ADDENDUM NO. 1

Greater New Haven Water Pollution Control Authority

2017 Collection System Assessment and Rehabilitation –
Wall Street Project
Project No. SSR 2017-03

Project No.: SSR 2017-03 | Sheet No.: 1 of

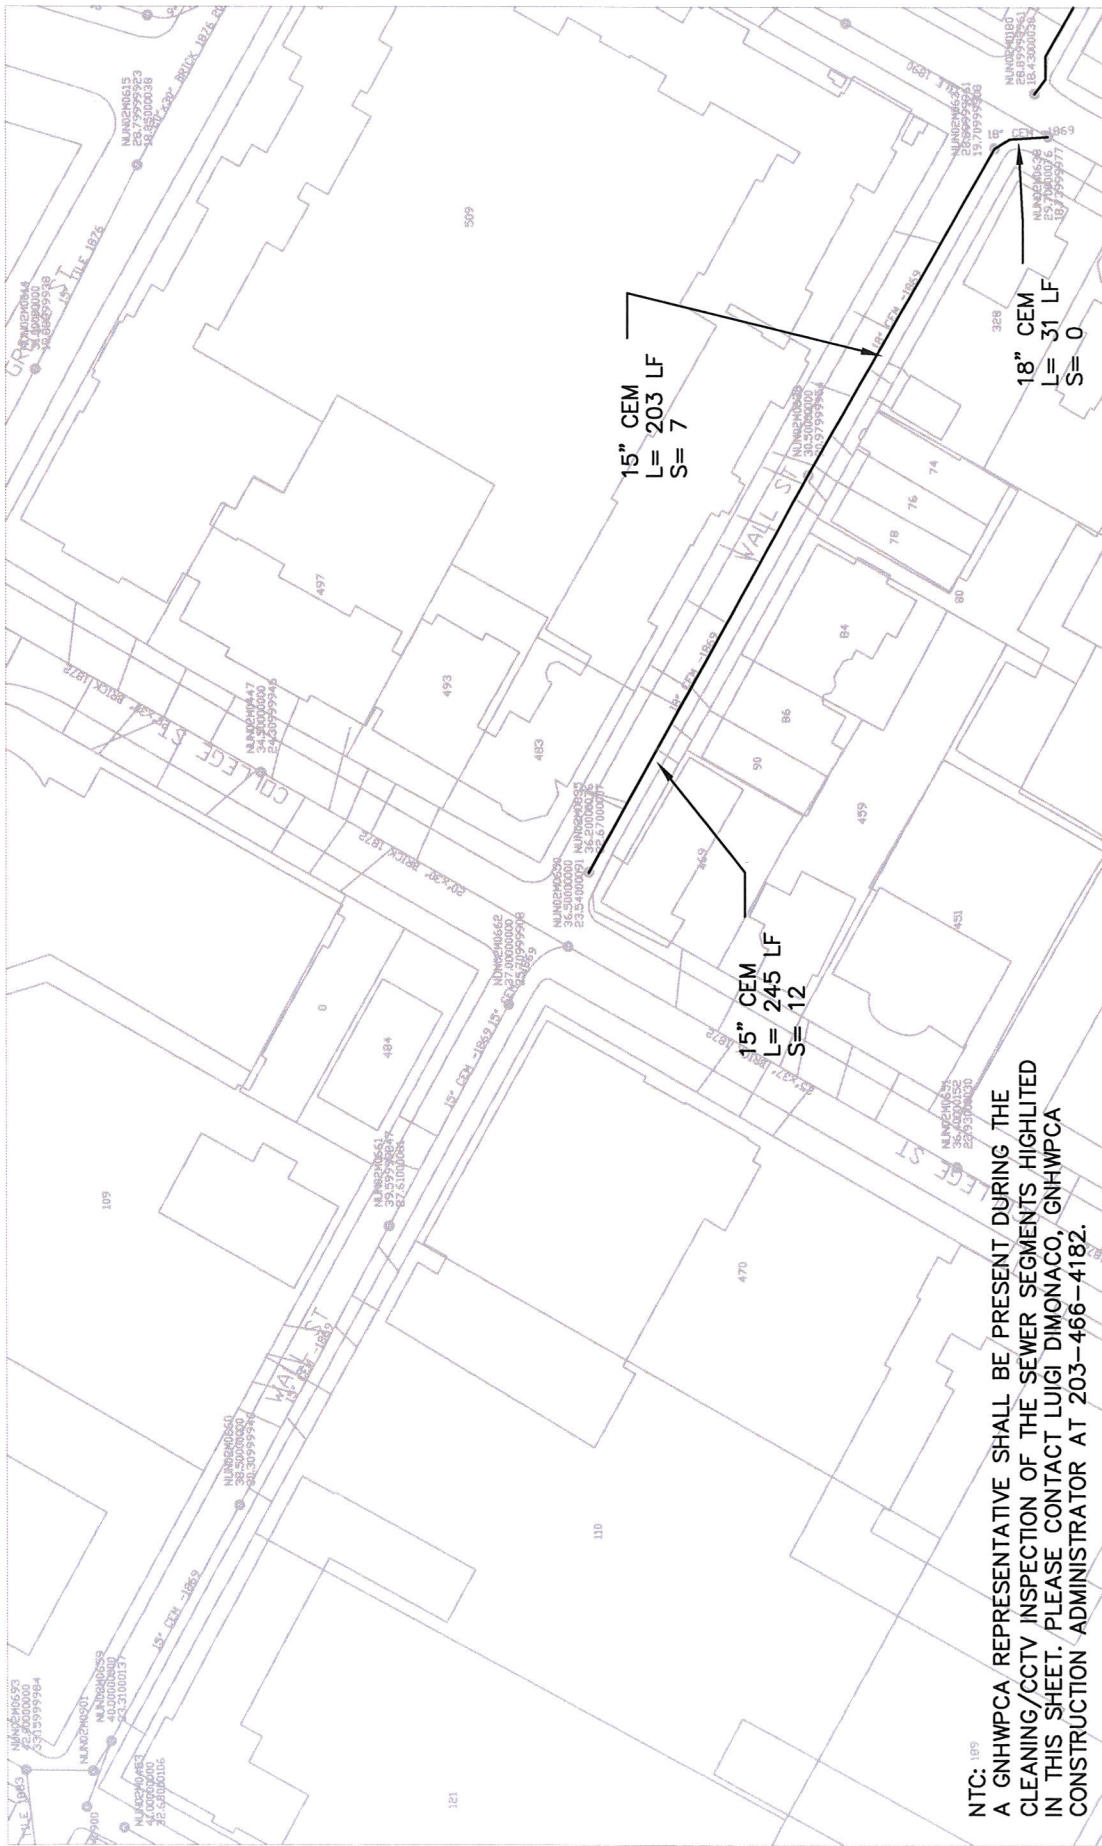
The 15" sewers on Wall Street between High Street and College Street have been removed from the Bid.

Replace Sheet No. 1 with the enclosed drawing revised 4/21/2017. Add the enclosed Sheet No. 8 to the Contract Documents.

Project No.: SSR 2017-03 Sheet No.: 8 of

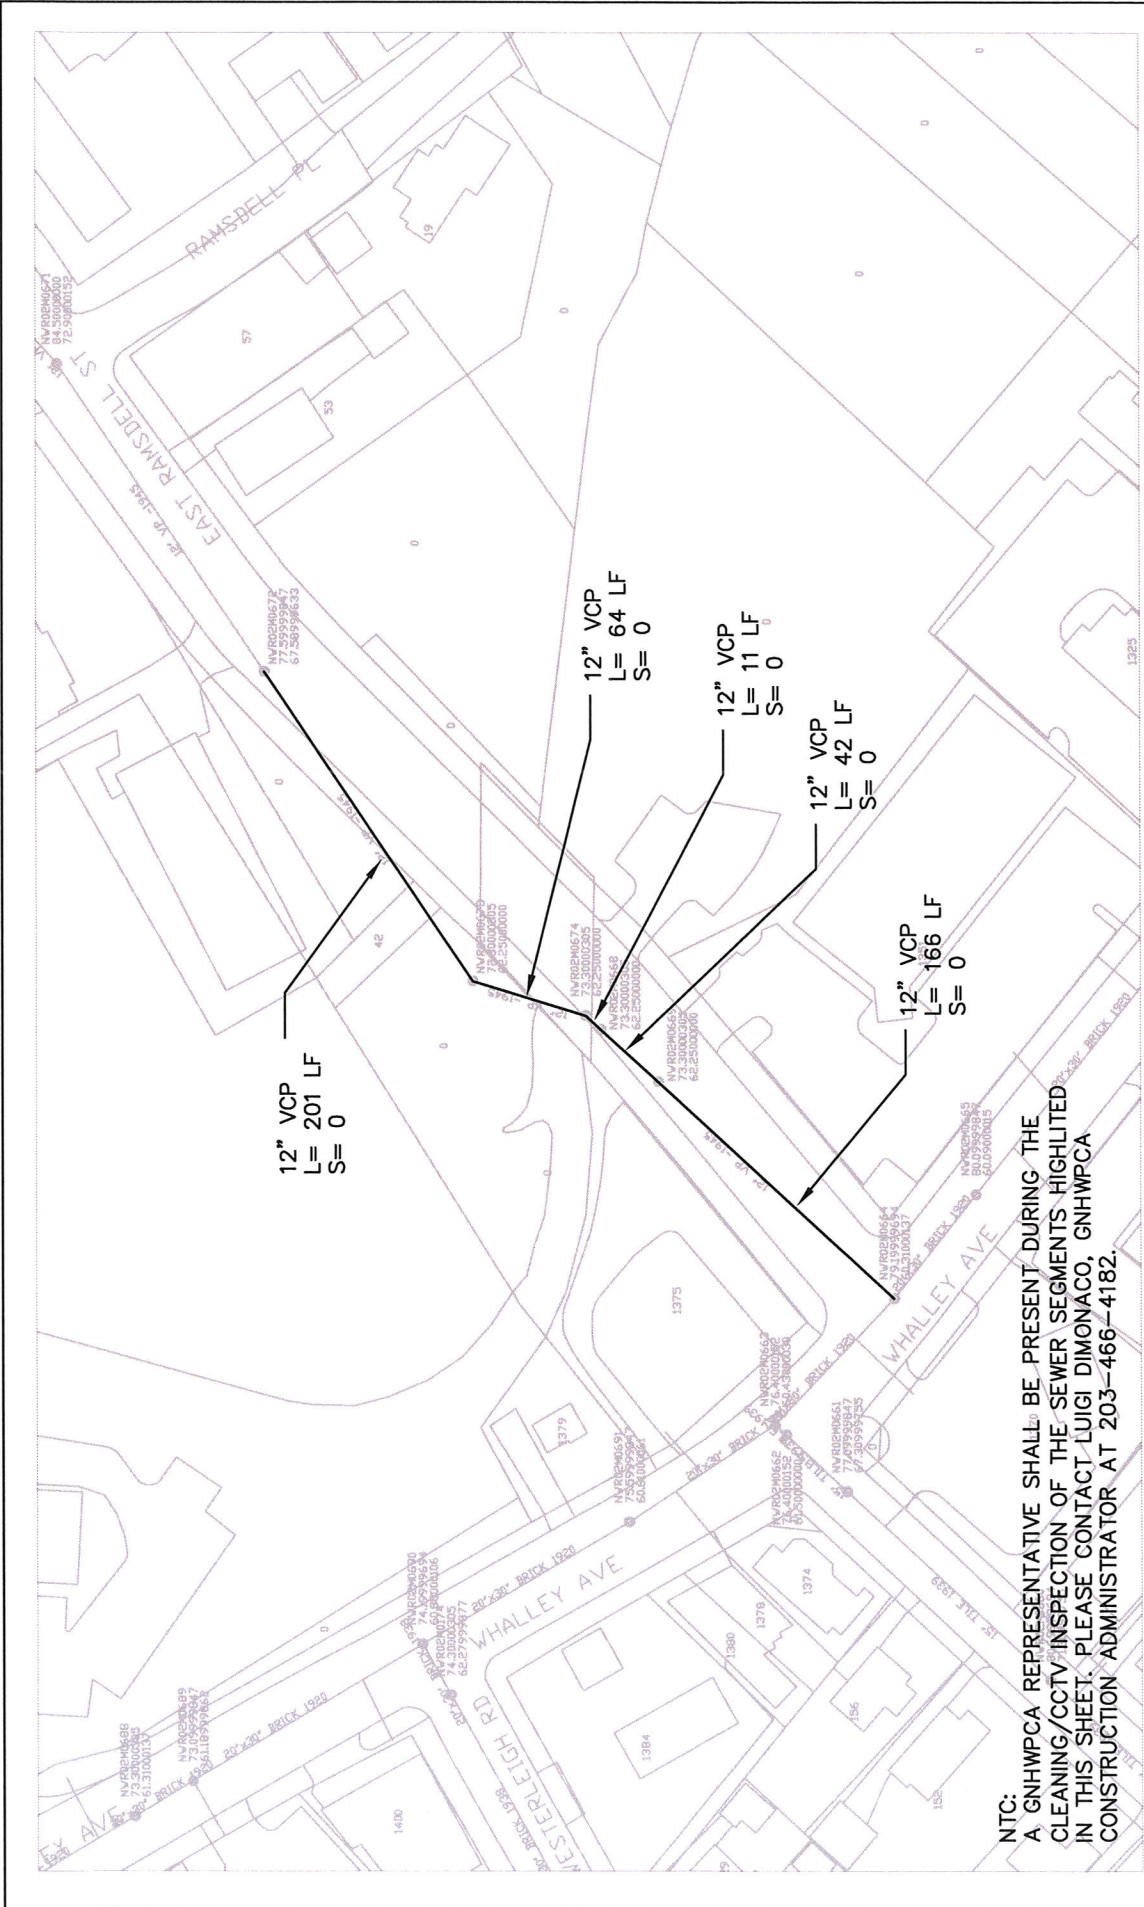
East Ramsdell Street has been added to the lining contract. The length of sewer to be rehabilitated on East Ramsdell Street is 484 LF of 12" VCP pipe.
